Regional Board Meeting January 24, 2007

Supplemental Executive Officer Summary Report Supporting Document # 4

January 24, 2007 Regional Board Meeting Item 11 Supplemental Executive Officer Summary Report, Supporting Document#4

Detailed Copermittee Comments on Tentative Order No. R9-2006-0011

Figure 1. Graph of survival vs. test concentration of stormwater illustrating how NOEC and LOEC are values based on point estimates of actual concentrations, while the LC₅₀ is a value that is calculated based on all of the measurements presented in the toxicity curve.

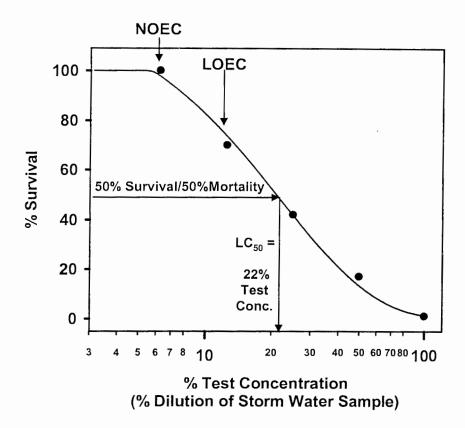
Acute toxicity tests are primarily used to determine the concentration of test water that produces a specific adverse effect on a specified percentage of test organisms during a short-term exposure period (i.e., usually < 4 days). In general, the key endpoint recommended in acute toxicity tests of effluents and receiving waters to freshwater organisms is the median lethal concentration (LC₅₀; Figure 1), or the concentration of test water to which test organisms are exposed that is estimated to be lethal to 50% of the test organisms (USEPA 2002a). The no observed effect concentration (NOEC), is a less commonly used, but accepted endpoint in acute toxicity tests, and indicates the highest concentration of test water in a toxicity test that has no statistically significant adverse effect on the exposed population of test organisms when compared to the controls (Figure 1). However, the NOEC is not recommended as an endpoint for the County of San Diego and Copermittees for two reasons. First, this endpoint does not indicate toxicity, but instead indicates a lack of toxicity. Second, while the LC₅₀ is a calculated value that is statistically determined based on all of the data points and the shape of the toxicity response curve (as shown in Figure 1), the NOEC is only a point-estimate concentration that is based in part on the experimental design, and the concentrations of test water chosen (Figure 1). Based on the above discussion, Weston recommends the LC50 as the key endpoint to be reported for the acute toxicity tests of storm water samples.

Figure 2. Example of no observed toxicity at any test concentration (dilution of storm water). In this example the NOEC = 100% storm water sample while the LOEC and the LC50 are greater than 100% storm water sample.

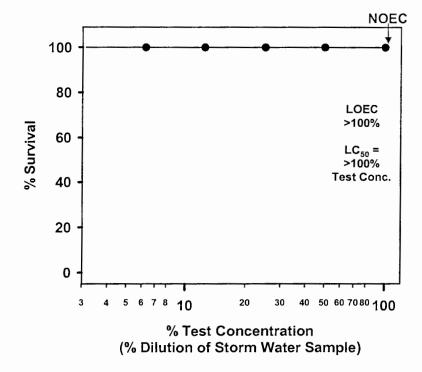
Table 3. Example of results with no observed toxicity. Recommended reporting for toxicity under new Tentative Order R9-2006-0011

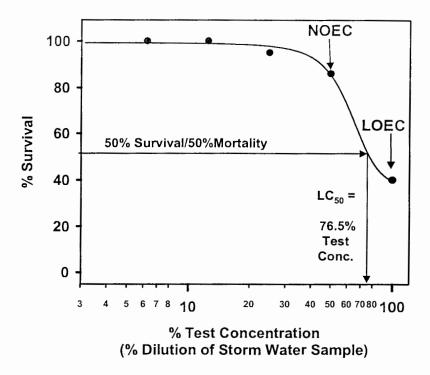
When determining whether a toxicity identification evaluation (TIE) should be performed on a sample demonstrating persistent toxicity, as defined above, there are additional criteria that must be met. If the persistent toxicity is occurring in an acute toxicity test of the storm water samples, then the there must be at least 50% mortality or greater in the 100%, or undiluted, storm water sample for the initiation of a TIE. For example, in Figure 3, there is only 40% survival in the 100% or undiluted storm water sample. Here, a TIE would be initiated, if this site had been predetermined as one demonstrating persistent toxicity.

In contrast, if there is only slight mortality (i.e. 25% mortality / 75% survival) in the 100% or undiluted storm water sample (as depicted in Figure 4), then a TIE may not be feasible. This is because most of the manipulations in the TIE are performed to test whether toxicity is removed from a sample after the chemical or physical manipulation. There must be statistically significant differences between treated and untreated samples to verify the cause of toxicity. Thus, if there is not significant toxicity at the beginning of the test, the TIE process may not differentiate between treated and untreated manipulations and would likely result in inconclusive TIEs.

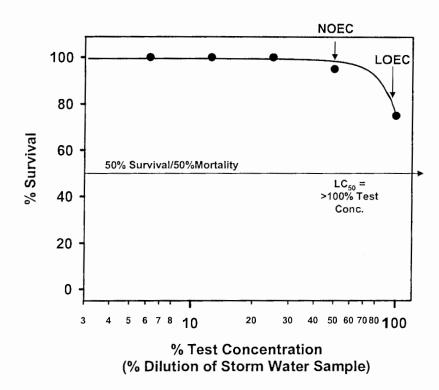
Similar to acute toxicity tests, if the persistent toxicity is occurring in a chronic test of the storm water samples, then there must be approximately 50% mortality or 50% toxicity (i.e., if the toxic effect is growth, reproduction, or a sublethal endpoint) in the 100% or undiluted storm water sample for the initiation of a TIE.

With regard to the information provided above, we have provided recommended changes to Table 3 (Triad Approach to Determining Follow-Up Actions) of the Tentative Receiving Waters and Urban Runoff Monitoring and Reporting Program (RWQCB Order#: R9-2006-0011). Recommended language changes are provided in Attachment A with changes highlighted in yellow.
